**Models Affected:**

This Campaign affects 2012 through 2016 model year Winnebago Era® motorhomes.

The affected vehicles were produced with a Vehicle Certification Label that incorrectly states the front tire inflation pressures. Incorrect labels will be replaced with correct ones.

**C**

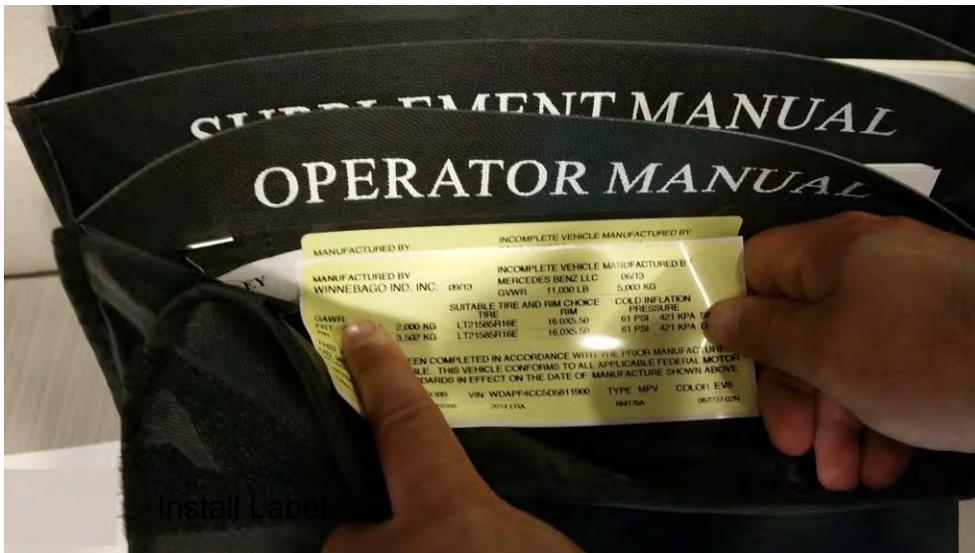
1. Cover the existing Vehicle Certification Label on the driver's door jamb with the corrected label included with this Campaign as shown in Photo C.

Install Label
